REMARKS

Appl. Serial No.: 10/691,866
Examiner: Jean B. Corrielus
Reply to Office Action of April 19, 2005

Amendments to the Drawings:

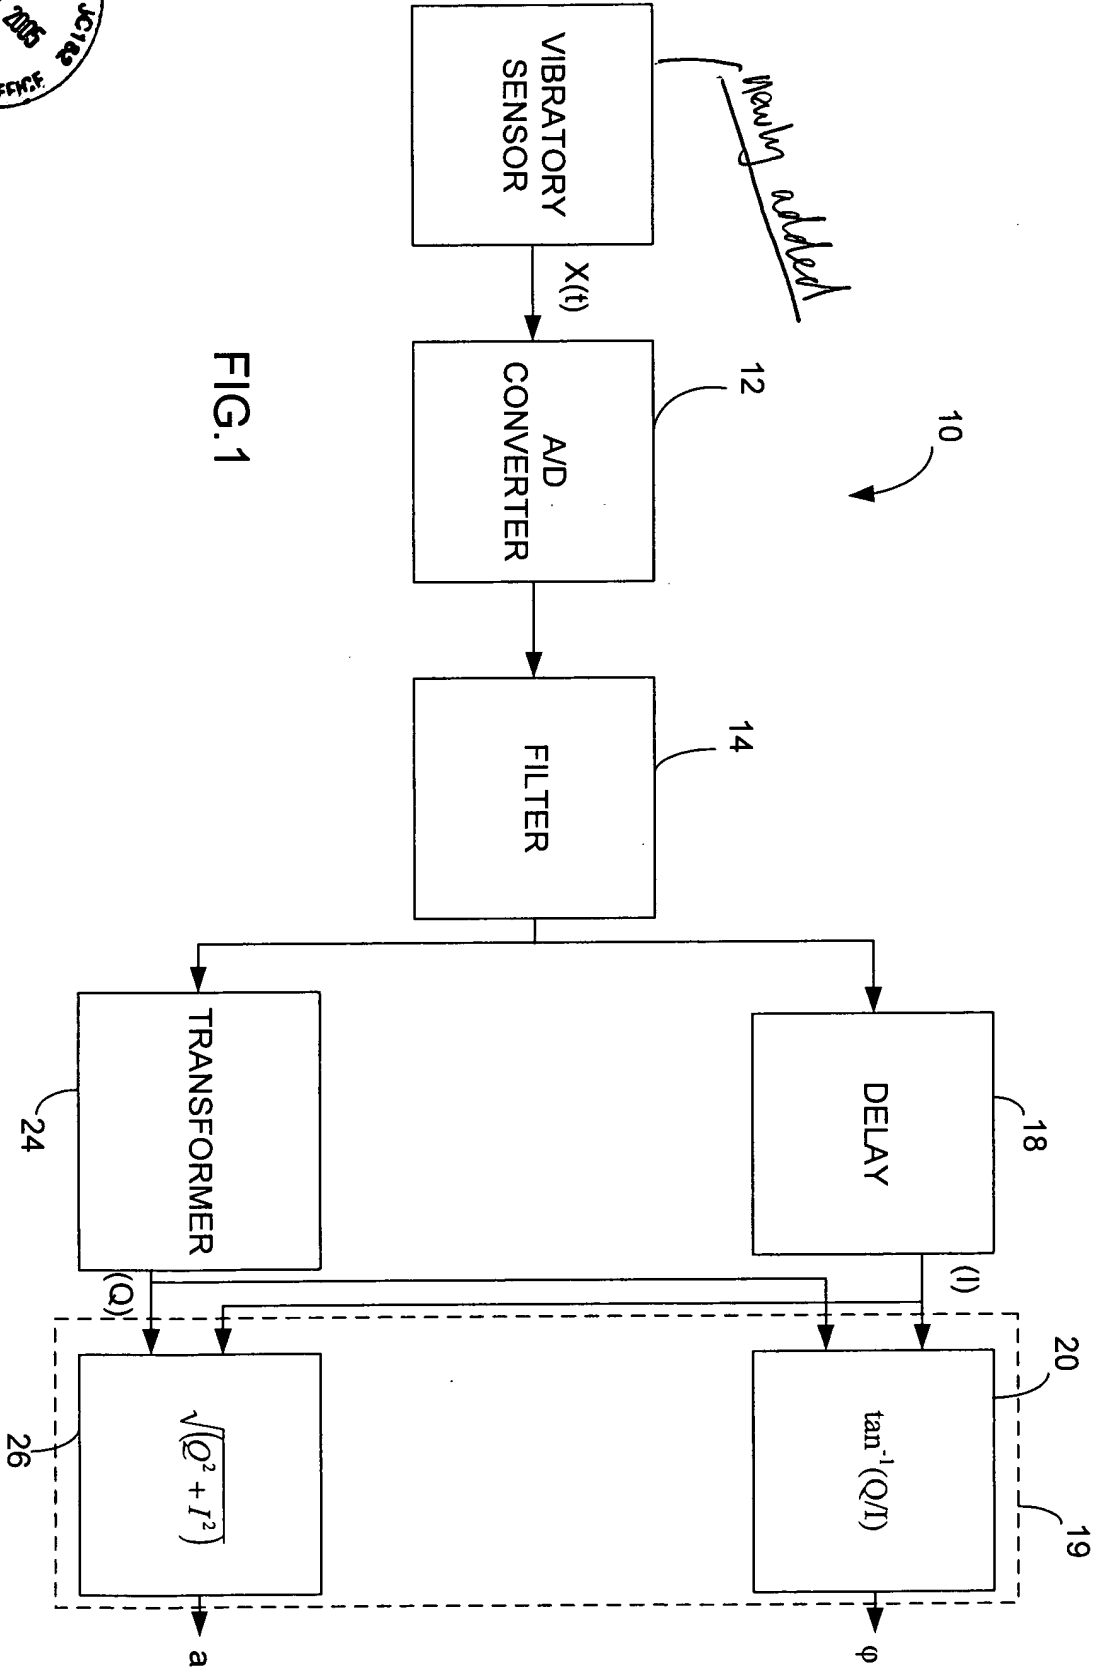
The drawings were objected to by the Office Action because the drawings do not show all the features of the invention specified in the claims. By this amendment, the applicants have amended FIG.1 and FIG.2. Two replacement sheets of drawings including FIG.1 and FIG.2 are enclosed in EXHIBIT A and two annotated sheets showing the changes are enclosed in EXHIBIT B. In the new substitute FIG.1, a block of VIBRATORY SENSOR is added at the beginning (most left part) of the flow chart. Support of this amendment can be found in paragraph No.13 at page 4 and in paragraph No.52 at page 10. In the new substitute FIG.2, a function block, which includes steps of MEASURING A PARAMETER OF AN OBJECT AND GENERATING AN ANALOG SINUSOID REPRESENTATIVE OF THE PARAMETER, is added at the head of the flow chart in FIG.2. The amendment is supported by the specification, for example in paragraph Nos. 39 and 40 at page 8. Therefore, no new matter is added. The amended drawings show all the features specified in the claims. Therefore, the objections to the drawings should be reconsidered and withdrawn.

Please substitute the enclosed two sheets of drawings including FIG.1 and FIG.2 (enclosed in EXHIBIT A) for the original FIG.1 and FIG.2. In the new substitute FIG.1, a block of VIBRATORY SENSOR is added at the beginning (most left part) of the flow chart. In the new substitute FIG.2, a function block is added at the head of the flow chart. The amendments are supported by the specification. No new matter is added.
